RE: 4 BMC Noise Mitigation for Public Open Space

Re: Stormwater Management **CONCEPT** Request
for 4 Bethesda Metro Center
Preliminary Plan #: 11981068A
SM File #: 284508
Tract Size/Zone: 3.48 Ac./CR-8.0,C-6.0,R-7.5
Total Concept Area: 0.92 Ac.
Lots/Block: P37/13
Watershed: Little Falls Branch

4 BETHESDA METRO CENTER

RE: Preliminary Plan No. 11981068B
4 Bethesda Metro Center

SHEET NO. **PP-4**

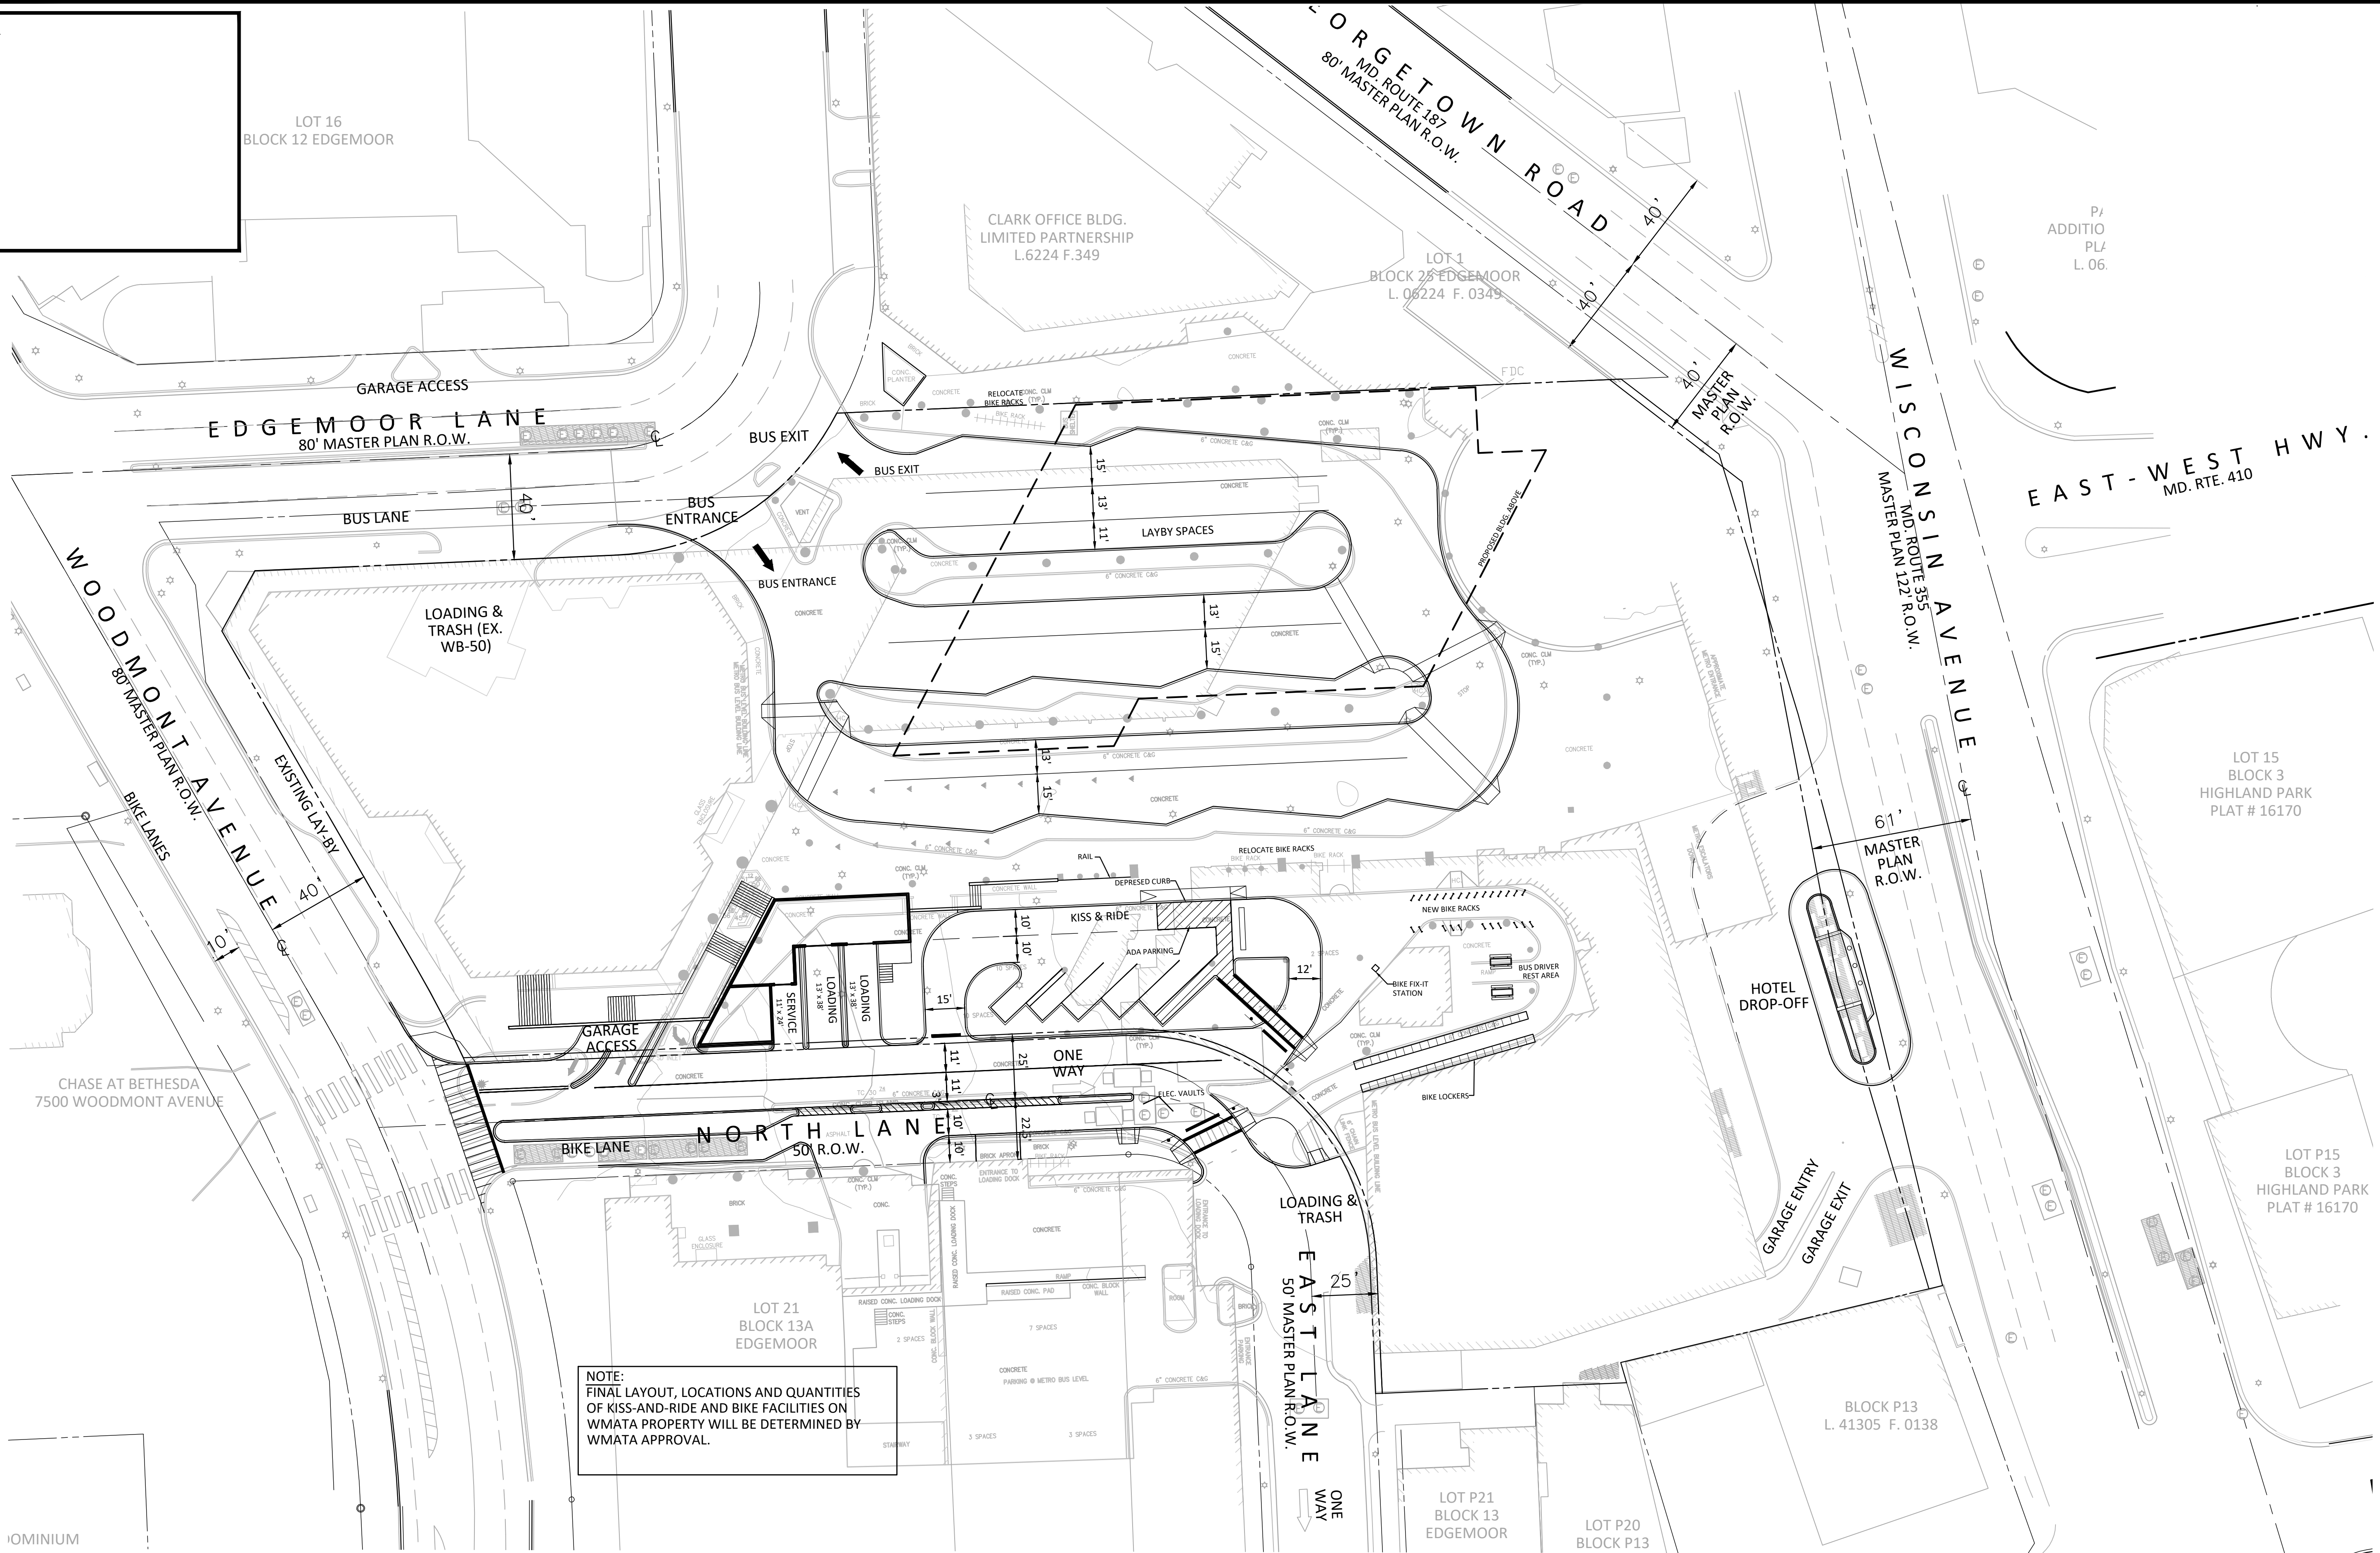
- 3. In order to meet the Bicycle Master Plan, the Applicant will:
 - a. Construct North Lane as shown on the preliminary plan sheet PP-4 titled "Preliminary Plan Bus Enlargement." The final details of layout will be determined at permit stage. The applicant must submit a plan and be approved by MCDOT prior the issuance of the right-of-way permit. The bike facility must be completed prior to issuance of the Use and Occupancy permit.

FIRE VEHICLE CIRCULATION

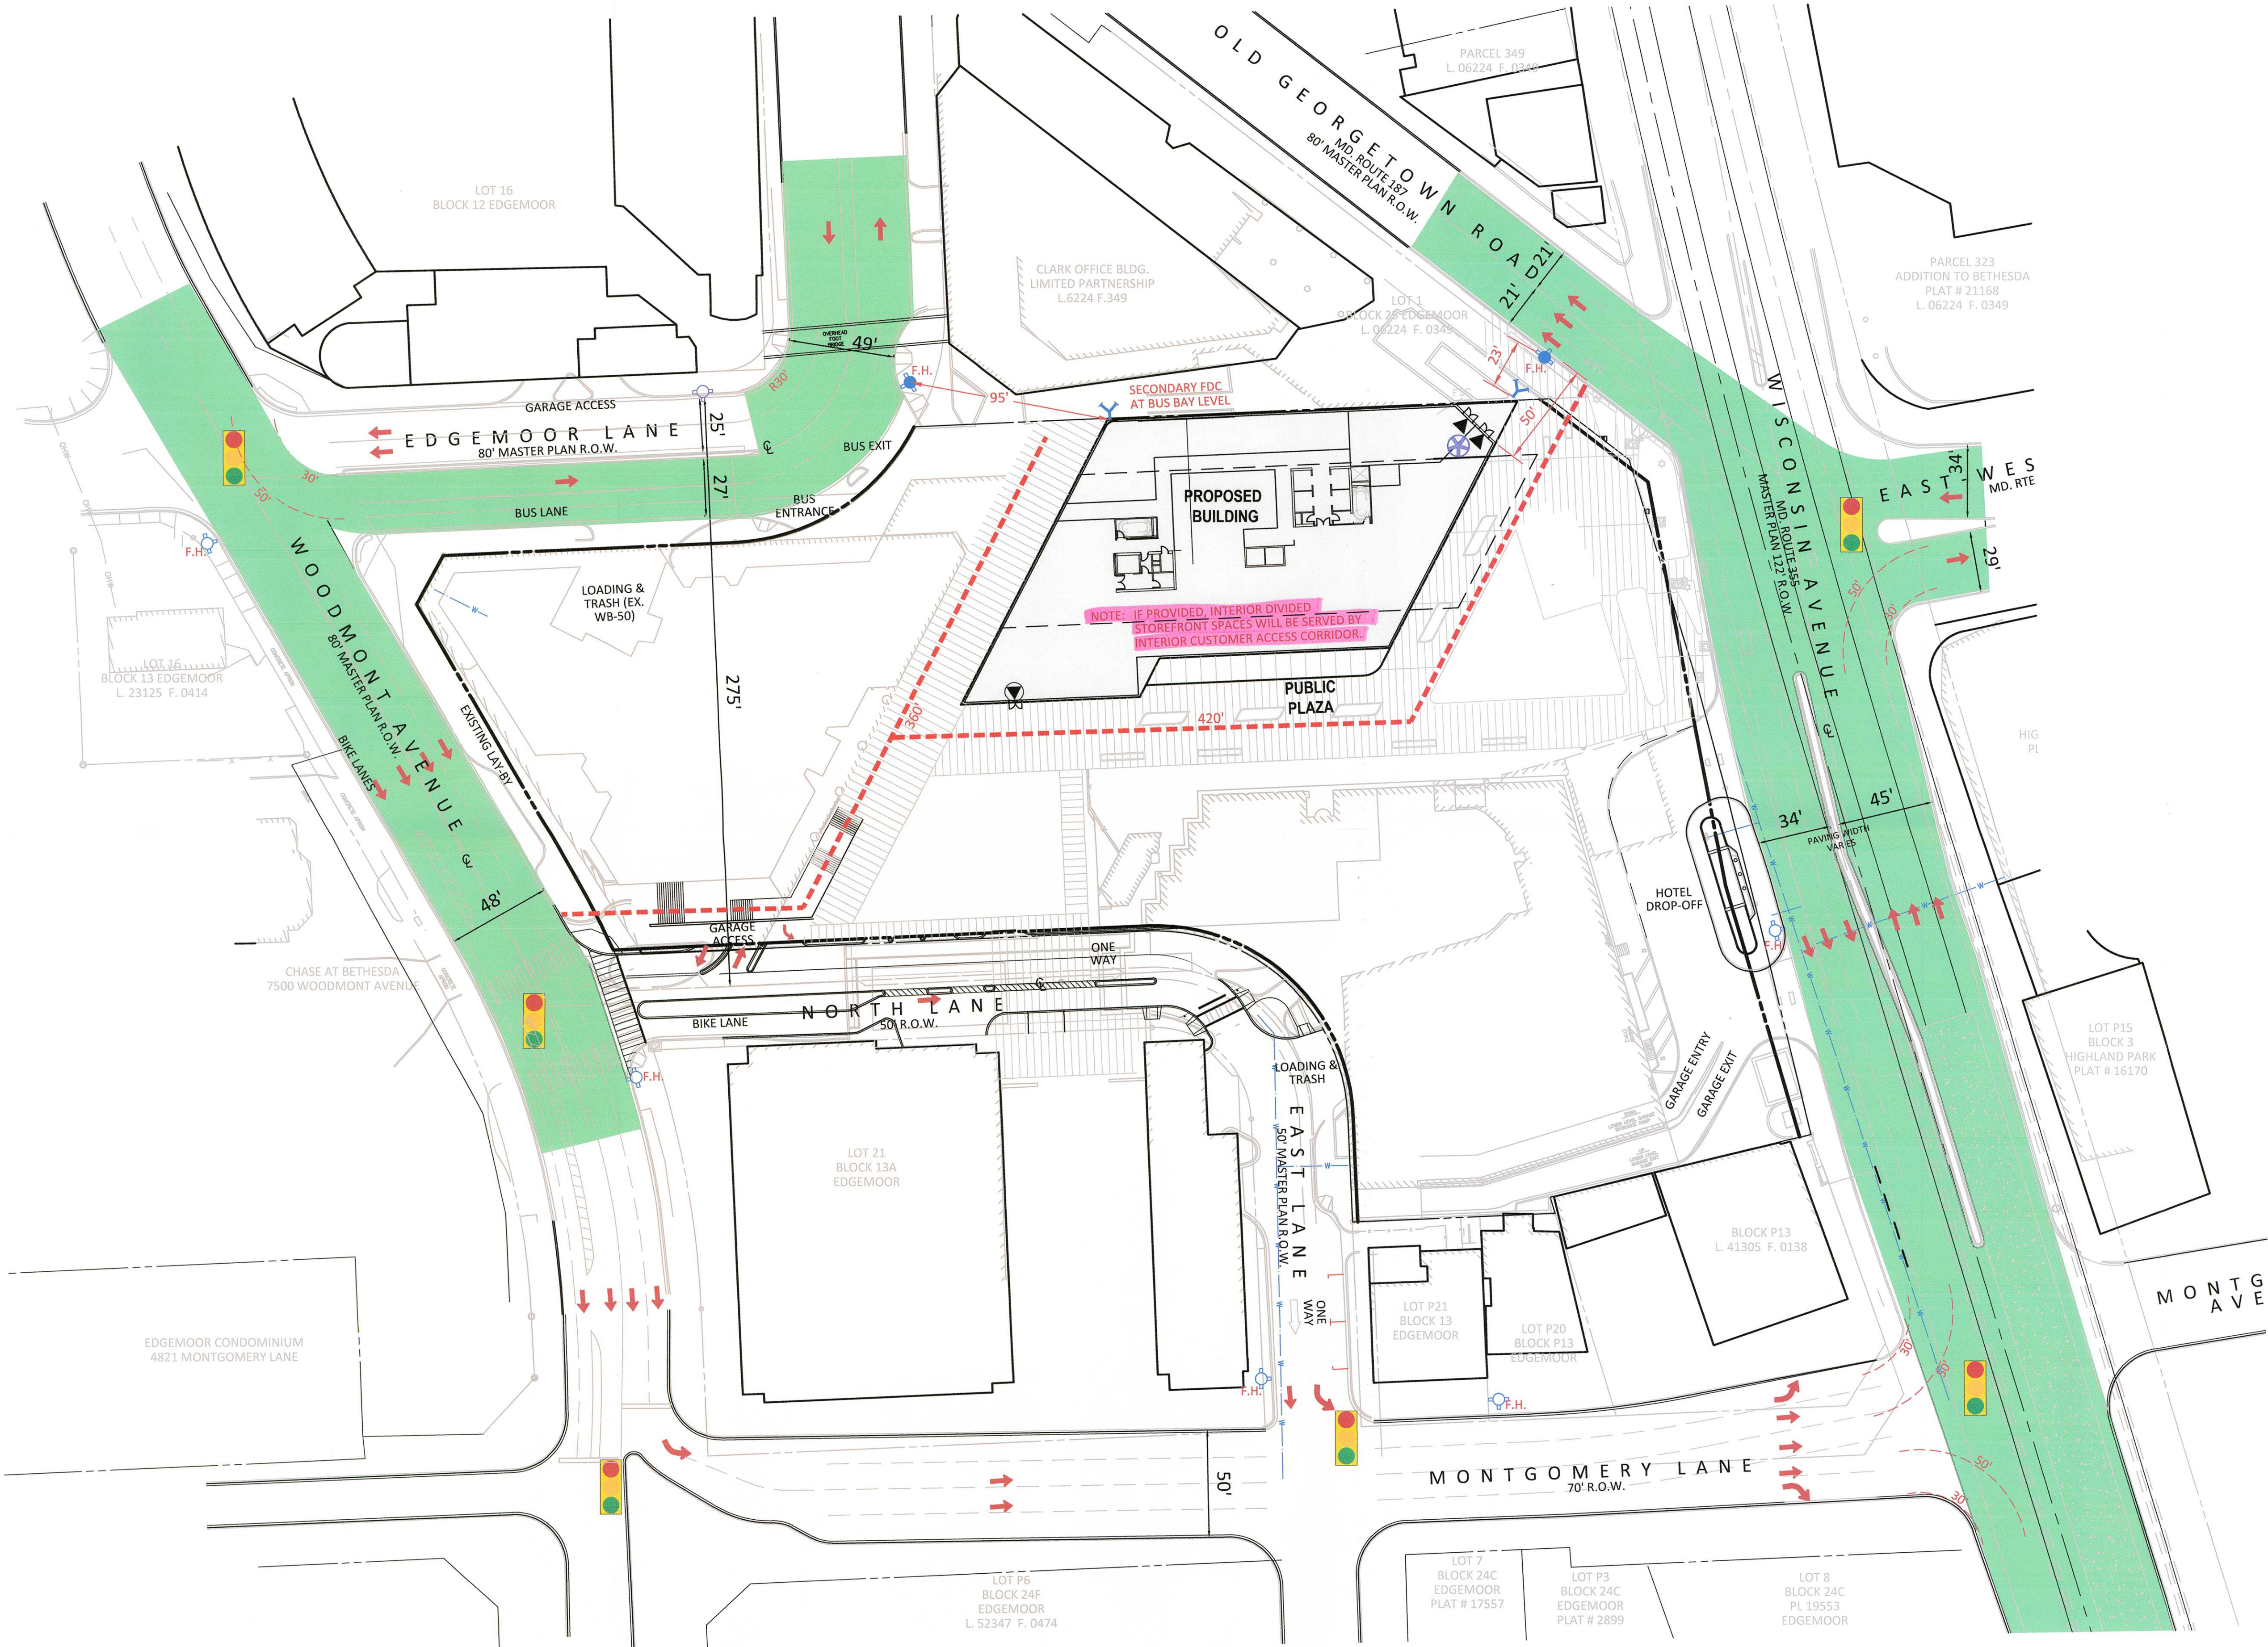
***** Any interior retail spaces must have main customer access from inside the main building via main lobby *****
